SERVICE BULLETIN

No.: MSB-00E35-001

Subject: CHANGE TO ERASING OF ABS DIAGNOSTIC CODES

<Model>
(EC)COLT/LANCER

ERASING DIAGNOSIS CODES

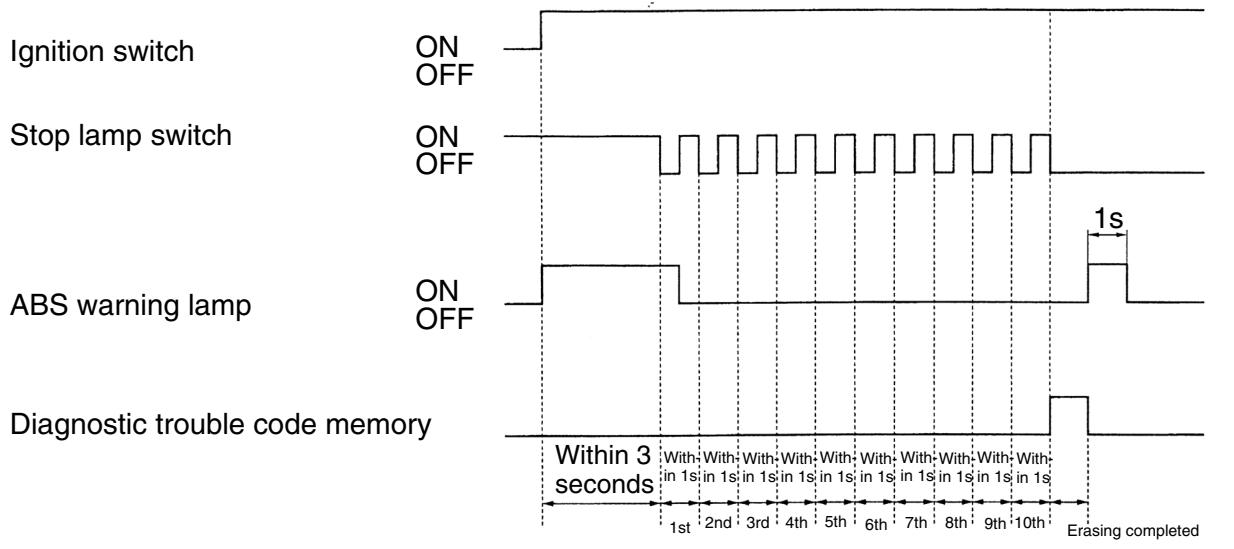
<Old>

With the MUT-II

Connect the MUT-II to the diagnosis connector (16-pin), and then erase the diagnosis codes.

Without the MUT-II

Remove the battery cable from the battery (-) terminal for 10 seconds or more, and then reconnect the cable.

With the MUT-II

Connect the MUT-II to the diagnosis connector (16-pin), then erase the diagnosis codes.

Caution

Turn the ignition switch off before connecting or disconnecting the MUT-II.

When diagnostic trouble codes (Nos. 21 to 24) (for vehicle wheel speed sensor system failures) occur, normal MUT-II operation may not erase those codes. In that case, erase the diagnostic trouble codes using the following procedures.

1. Perform erasing of the diagnostic trouble codes by special operation of the brake pedal. (See erasing procedure for the diagnostic trouble codes without use of the MUT-II.)
2. Turn the ignition switch OFF.
3. Perform erasing of the diagnostic trouble codes by use of the MUT-II.

Without the MUT-II

1. Stop the car.
2. Place the stop lamp switch to ON (with brake pedal depressed).
3. Under the condition of 1 and 2 above, turn the ignition switch ON. After that, place the stop lamp switch to OFF (with brake pedal released) within 3 seconds, and cycle the stop lamp switch ON and OFF ten times consecutively.

When ABS-ECU stops functioning through the fail-safe mechanism, erasing of the diagnostic trouble codes cannot be performed.

4. Ensure that the diagnostic trouble codes have been erased. When diagnostic trouble codes (Nos. 21 to 24) (for vehicle wheel speed sensor system failures) occur, the above procedures may not erase those codes. In that case, turn the ignition switch OFF, then repeat steps 1 to 3 above.
